Proposal Request

PROPOSAL REQUEST 100

BRASS PANELS ADDED TO BACK OF PRECAST AT NORTHWEST PORCH

PROJECT: AWSOM
BENTONVILLE, AR

1 | L1 - NOTE PLAN - AREA B
1/8" = 1'-0"

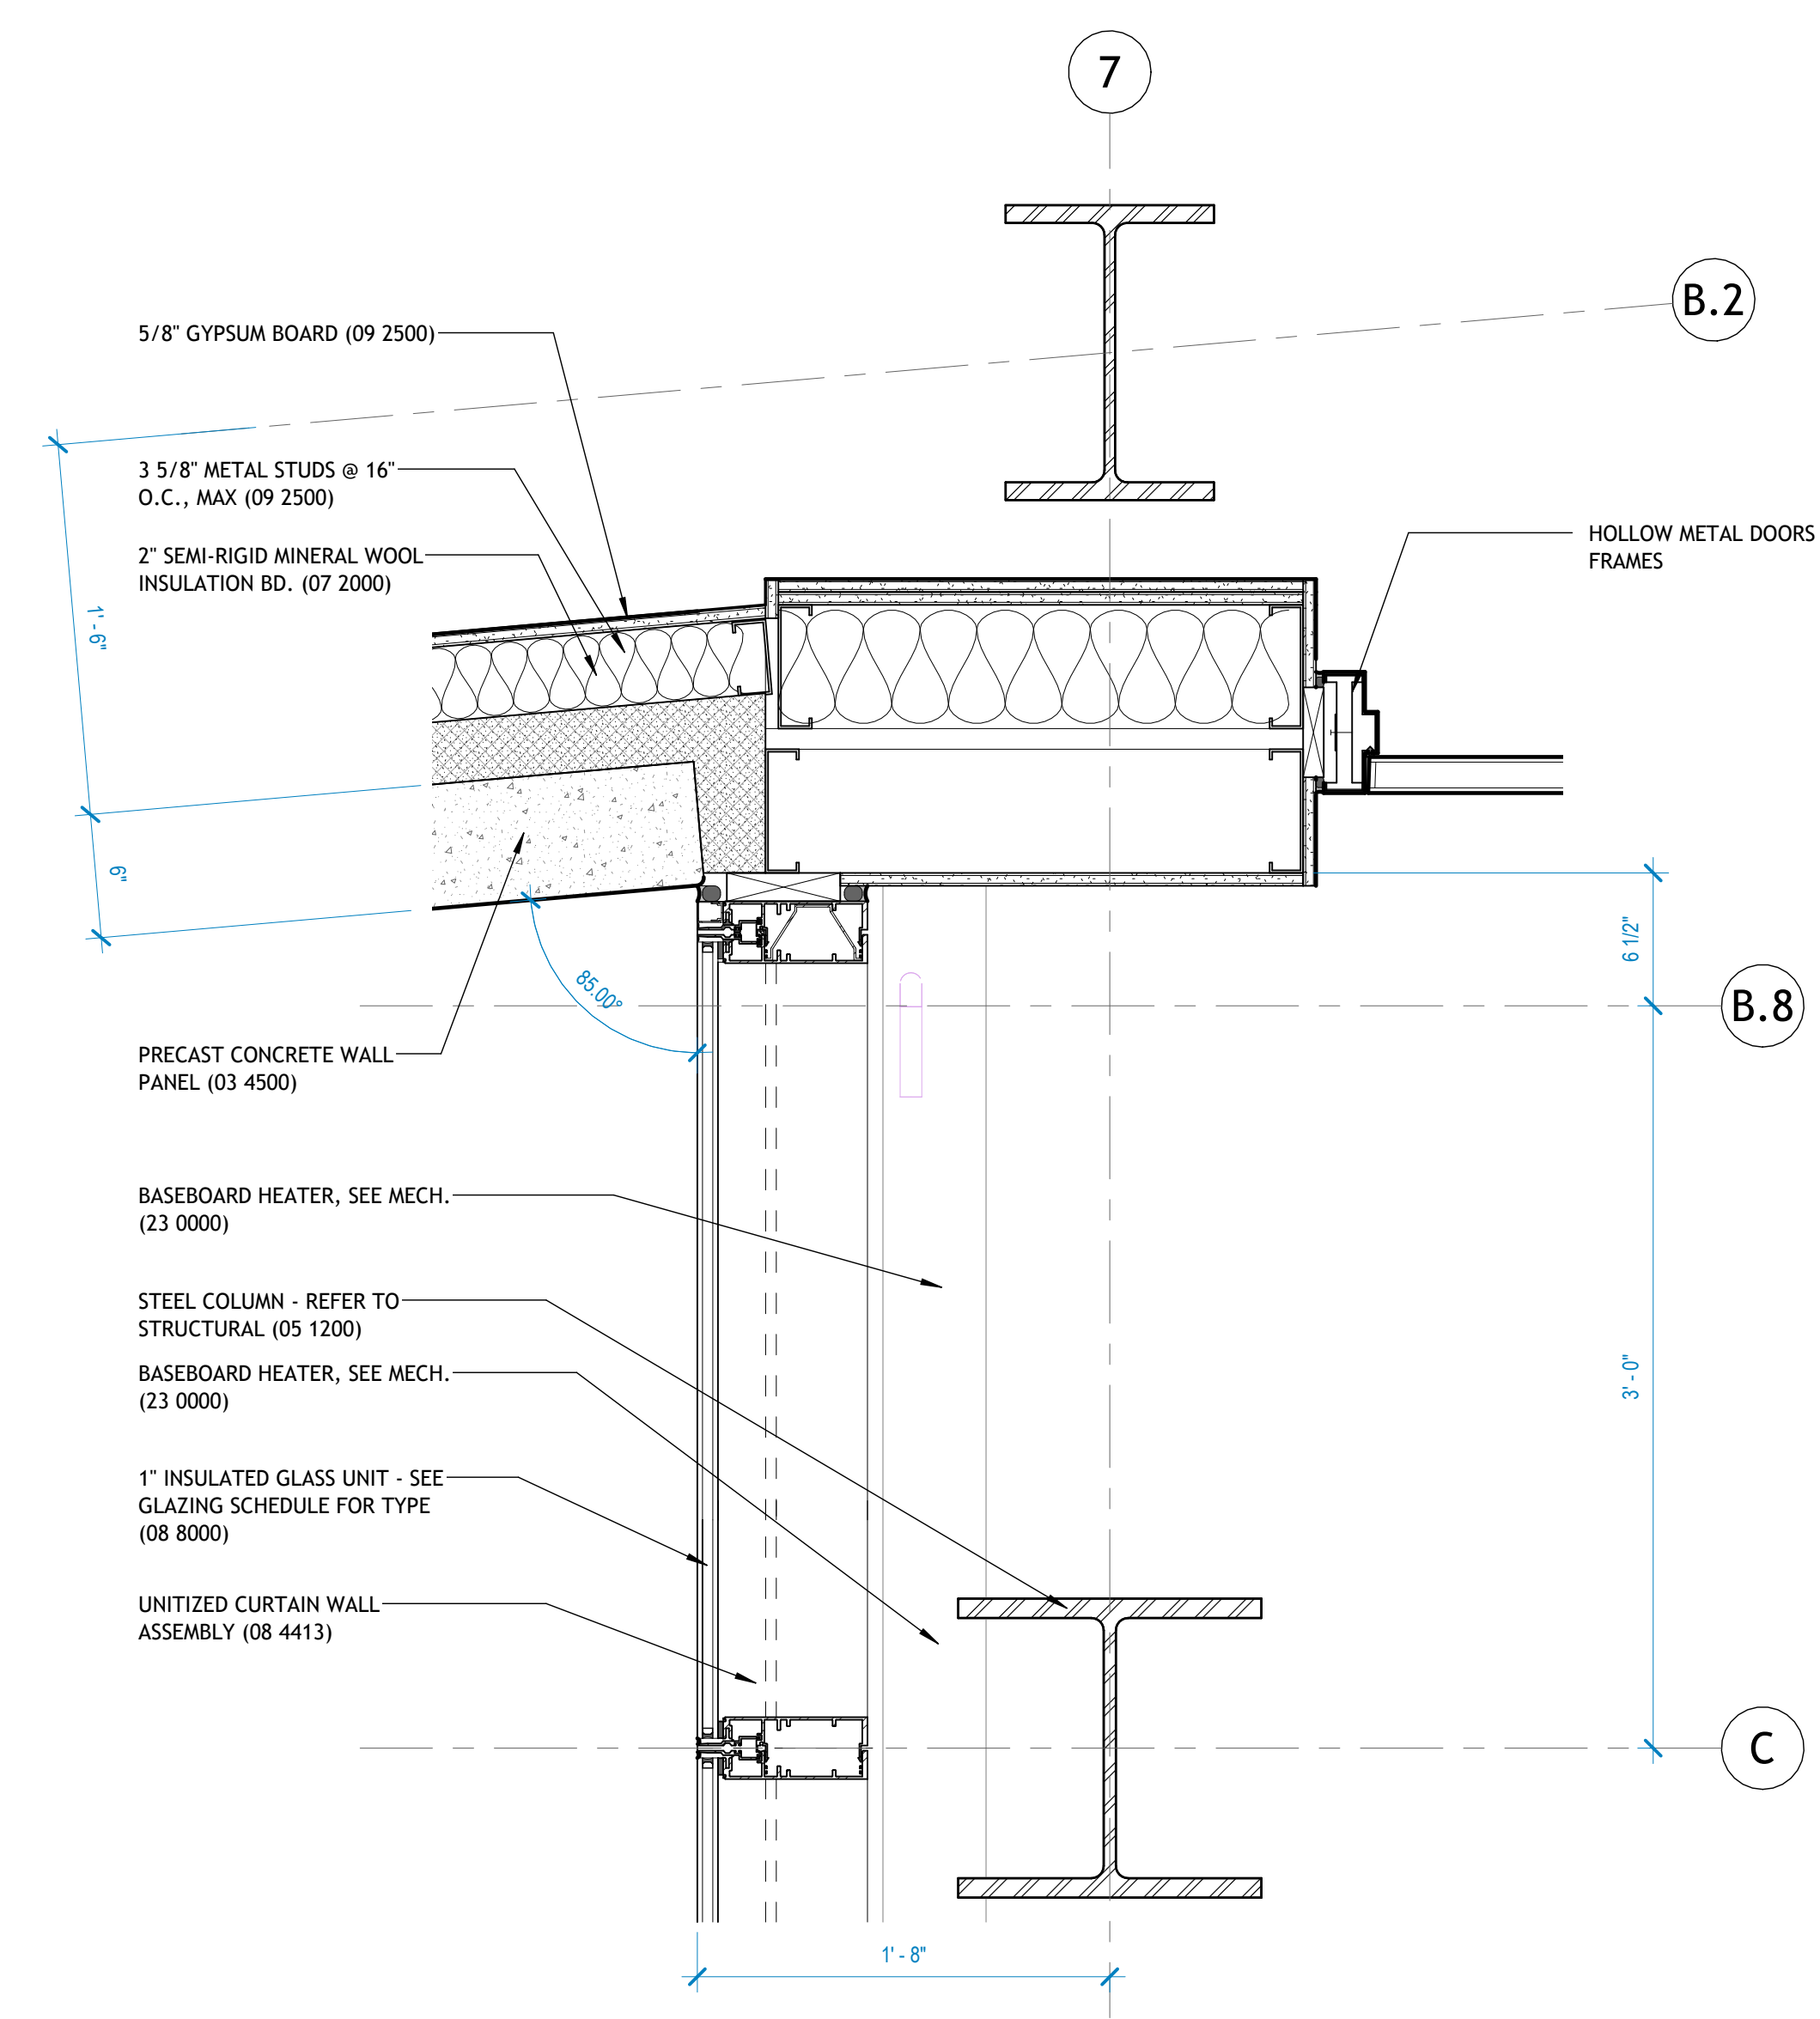
1. A101B NOTE PLAN – LEVEL 1 AREA B
 - a. Added brass wall panels at back of precast panels along grid A between grids 1 & 2
 - b. Added brass wall panel elevation 15/A775
2. A503 PLAN DETAILS – EXTERIOR
 - a. Revised detail 6 L1 – WEST PORCH FIN AT PRECAST to include brass wall panels and trim to back of precast panels
3. A775 BRASS PANEL – BIKE GROTTA
 - a. Added brass panel elevation 15
